Kilchis Porter Restoration Review

Final Report, Rev. 2

The Nature Conservancy

The Nature Conservancy (TNC) contracted with Northwest Hydraulic Consultants (NHC) to perform a technical hydraulic review of one completed (Dooher) and one planned (Porter Tract) restoration project on the TNC-owned Kilchis Estuary Preserve. The scope of work was developed in concert with the Tillamook County Creamery Association (TCCA) and Tillamook Bay Flood Improvement District and consisted of twelve items to be addressed. TNC provided all relevant reports, data, and hydraulic models to be reviewed. In the report body the twelve items are addressed individually even though there is some overlap and common elements between them. This executive summary describes the key findings of the review, which in some cases are synthesized from the analysis of several scope items.

Figure 20: Simulated Kilchis River profiles at various flows and tides

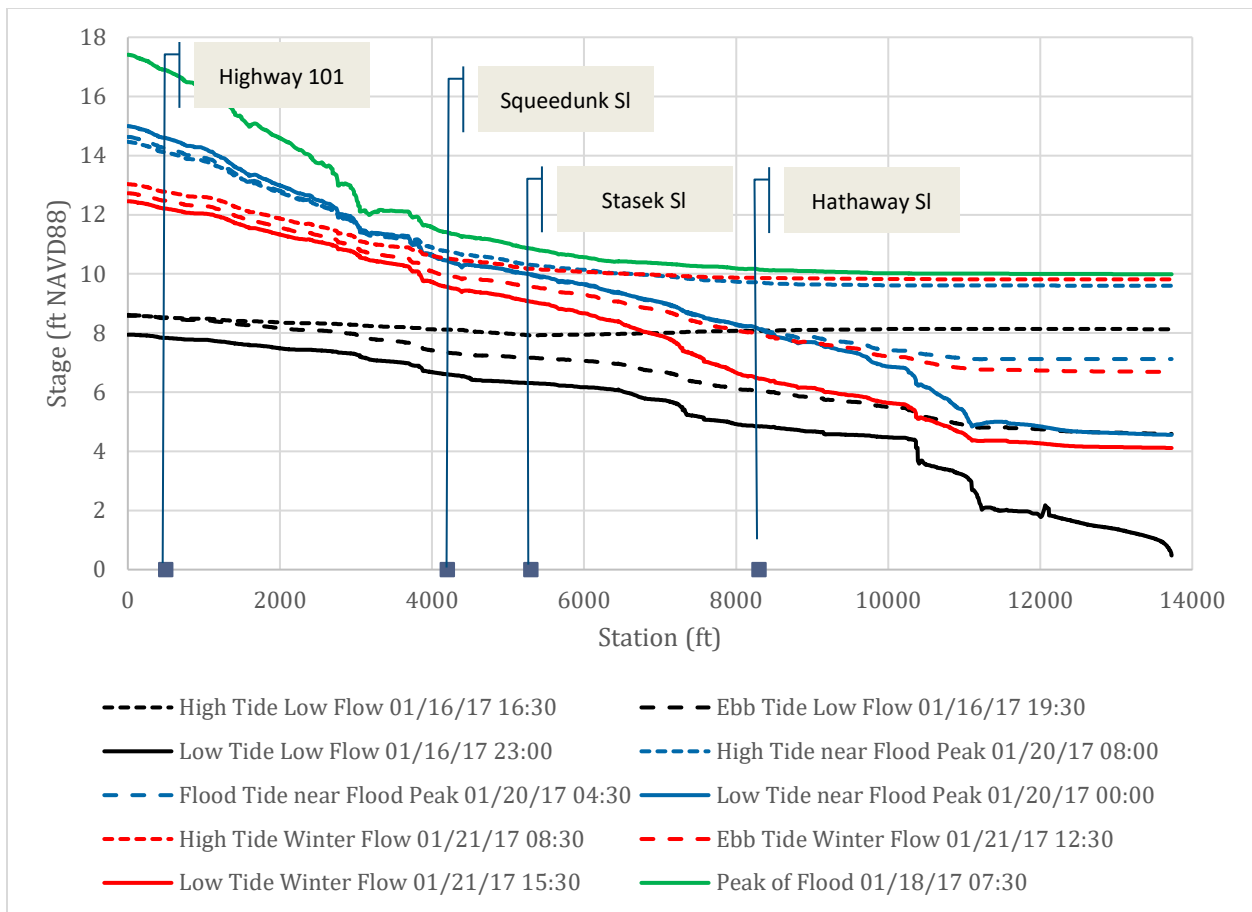
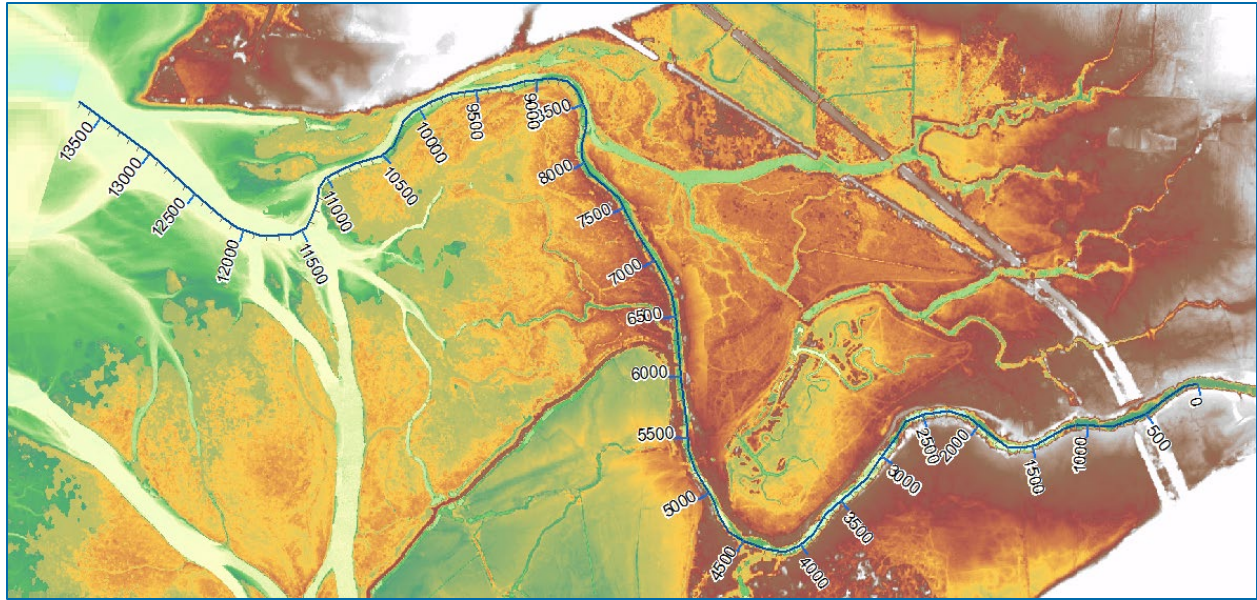
Simulated water surface profiles from high, mid, and low tides for different flows are shown in Figure 20. The figure shows high tides in the Kilchis River at Stasek and Hathaway Sloughs are very similar, but Hathaway Slough is one to three feet lower during mid and low tides. This agrees with the observed gage data already discussed (Figure 10). The point made in the Kuntz letter is that better drainage is obtained from connecting to the river at Hathaway Slough, as was the case for Stasek Slough prior to the Dooher project. This is somewhat of a simplification: the connector culvert restricted flow from Stasek to Hathaway prior to the Dooher project, and even without the culvert we would expect some head loss between the two sloughs. Squeedunk Slough also complicates things to some degree. In keeping with the staircase analogy, Squeedunk is another staircase that offers an alternate route to Tillamook Bay. Nevertheless, the basic point made in the letter is borne out by both the observed and modeled data.

Figure 22: Simulated HEC-RAS flow in connector culvert/channel and total floodplain flow under existing and proposed Porter project conditions. Bottom figure is close-up to show non-flood (contained in channel/culvert) flows.

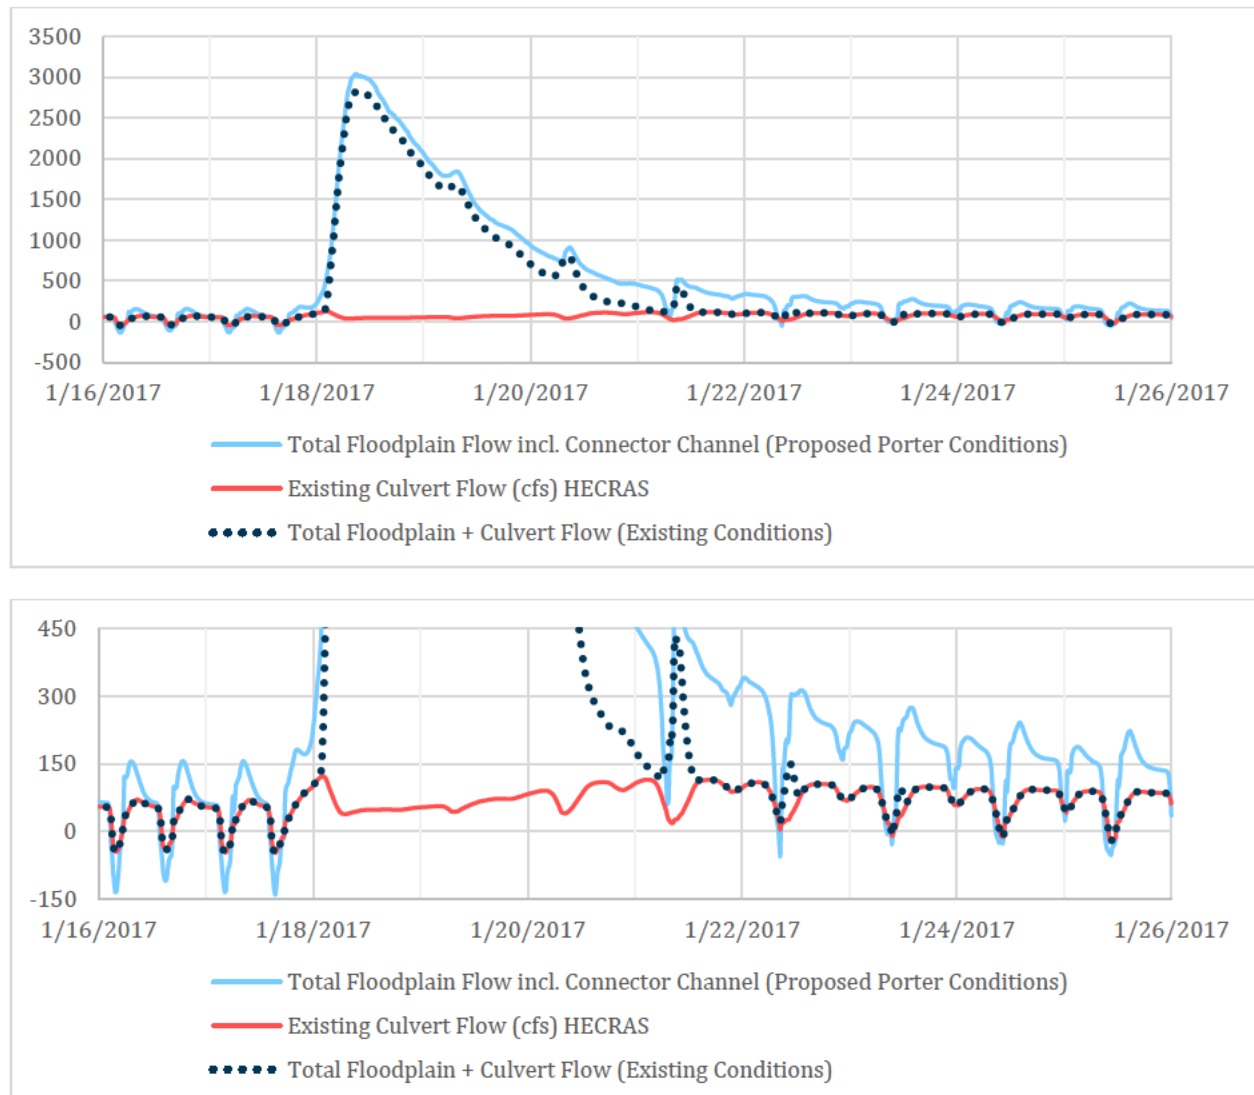
The existing box culvert exerts a strong control on water levels in Stasek Slough and regulates flow from Stasek into Hathaway Slough during normal winter flows. In the summer, water levels are more equalized throughout the area and the box culvert appears to have a much smaller effect on water level regulation. The degree of regulation is most evident in the water surface elevation difference between Hathaway and Stasek Sloughs that has already been discussed. Comparison of the Hathaway and Connector Channel (located just downstream of the culvert) gages shows close matches, especially at normal winter flows (i.e., October 19-20, Figure 21), indicating that most of the water surface differential between the Stasek and Hathaway Sloughs occurs at the culvert, rather than being distributed downstream along Porter Slough. This is a strong indication that the culvert is restricting flow.

Under normal flow conditions, the HEC-RAS model predicts flow through the culvert to be about 70 to 100 cfs towards Hathaway Slough. Under low flow conditions, flow reversals of 50 cfs occur on the flood tide (bottom, Figure 22). With higher river flows, reversals are minimal or missing, meaning the culvert is always flowing towards Hathaway Slough regardless of the tide. This flow is drawn in from the Kilchis River via Stasek Slough. The culvert has minimal effect during floods compared to the total flow over the floodplain between the Kilchis River and Highway 101 (top, Figure 22). Another indication of the regulation provided by the culvert is shown by the effects of removing it, as is proposed for the Porter project. We have discussed previously the reduction in stage in Stasek Slough and increase in stages in Hathaway Slough; Figure 22 (bottom) shows how removing the culvert and widening the channel doubles the flow through the cut between Stasek and Hathaway Sloughs during non-flood periods, explaining this effect.

Figure 23: Flowpaths and depths during peak of January 2017 flood from NHC HEC-RAS model. Levees to be removed as part of Porter Project outlined in red.

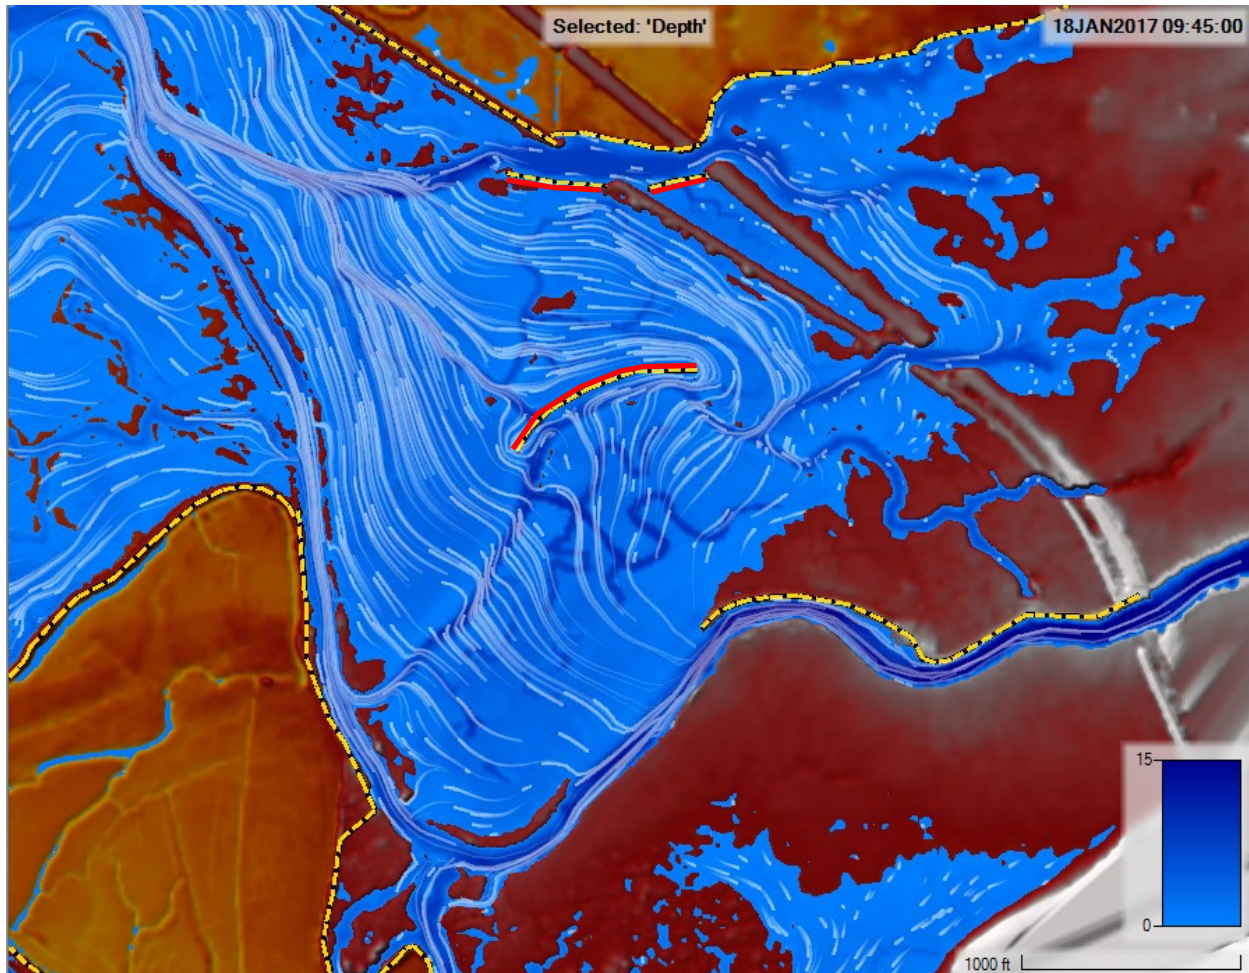
Analyzing the effects of this element of the proposed Porter project in isolation from the other elements would require additional modeling effort. Our examination of LiDAR, the Doohar design plans, and Porter plans leads us to believe that the Doohar project removed most of the levees that were impediments to flow in the area. Our opinion is that removal of the existing culvert and widening of the

Stasek-Porter Slough connector channel is the most consequential action of the proposed Porter project, and removal of levees probably only has small secondary effects on flood hydraulics. The reasons why the levees proposed for removal as part of the Porter project will not have a significant effect can be seen in Figure 23. The north bank Stasek Slough levee blocks flow, but there are wide expanses of floodplain on either side that the flow already uses. Flow is parallel to the two Hathaway Slough levee removals and both sides are flooded, so these structures do not block the flow in any meaningful way.
